APPLICATION FOR ZONING RELIEF AND CERTIFICATE OF APPROPRIATENESS HISTORIC CONSERVATION BOARD PUBLIC HEARING STAFF REPORT

APPLICATION #: ZH20210034/COA2021011
APPLICANT: Northcrown Property- Dominic Sansalone
OWNER: Northcrown Property
ADDRESS: **139 E McMicken Ave**
PARCELS: 094-0007-0366
ZONING: CC-P
OVERLAYS: Over the Rhine Historic District
COMMUNITY: Over the Rhine
REPORT DATE: April 12, 2021
STAFF REVIEW: Beth Johnson, Urban Conservator

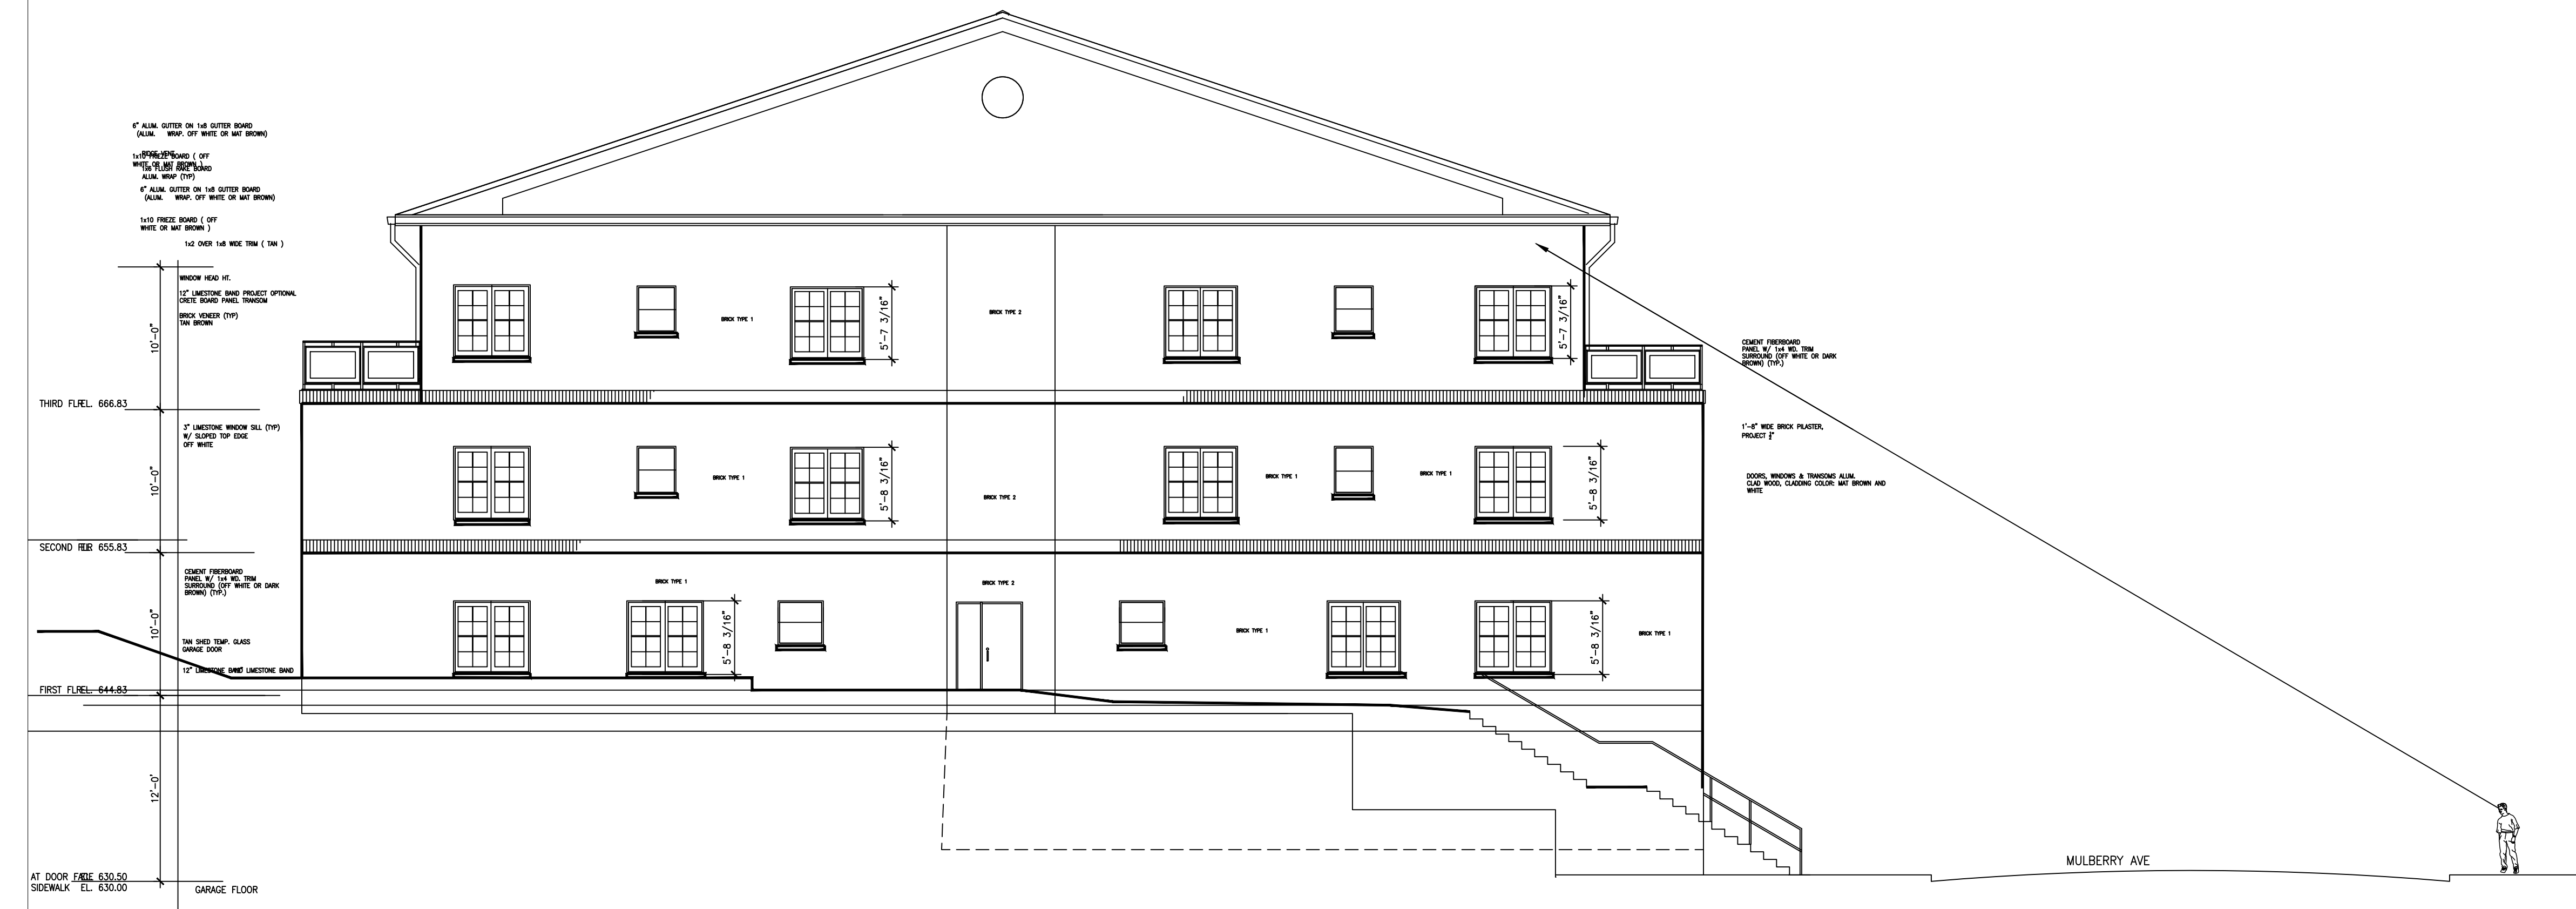
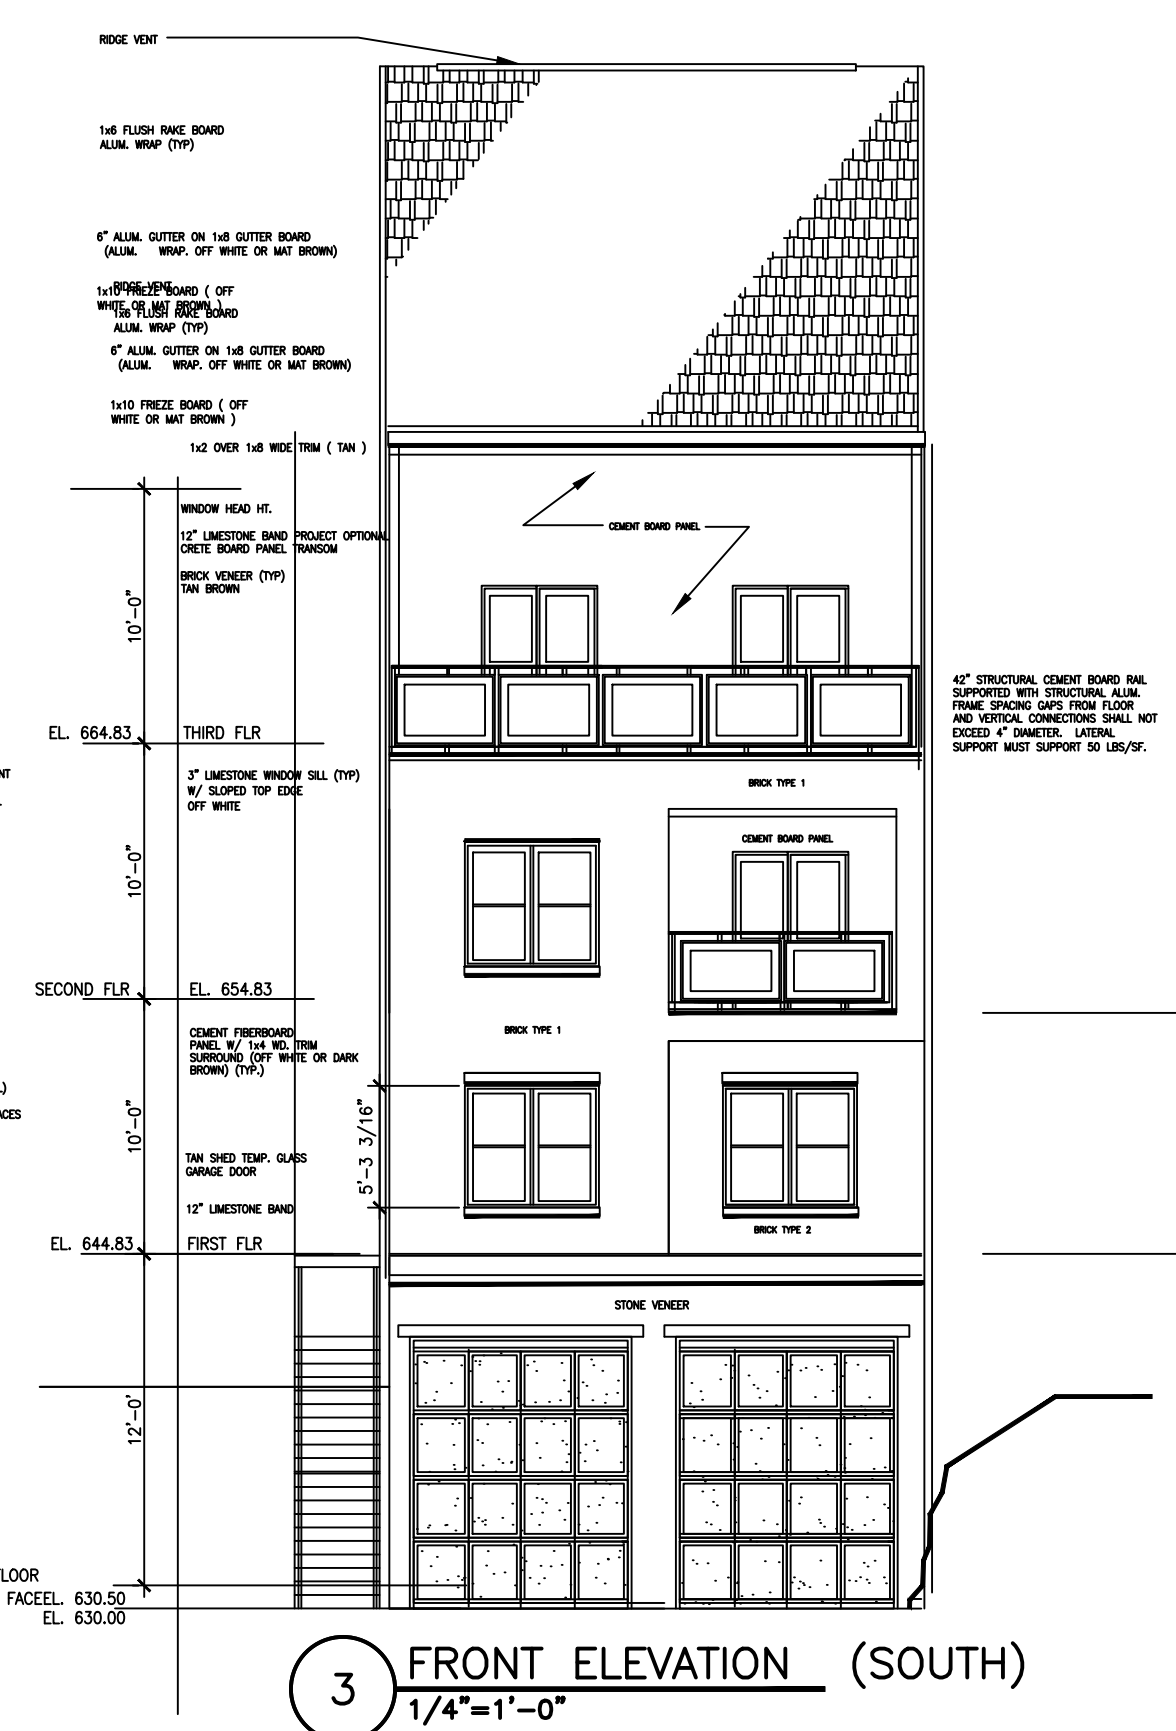
On the plans A300 there is also a discrepancy on the plans between the side elevation and the rear elevation and the rear deck. On the side elevation the deck is shown but on the rear elevation the deck is not present. Staff will recommend that either option would be appropriate but the architect needs to select one prior to building permits being issued to make sure the elevations are accurate.
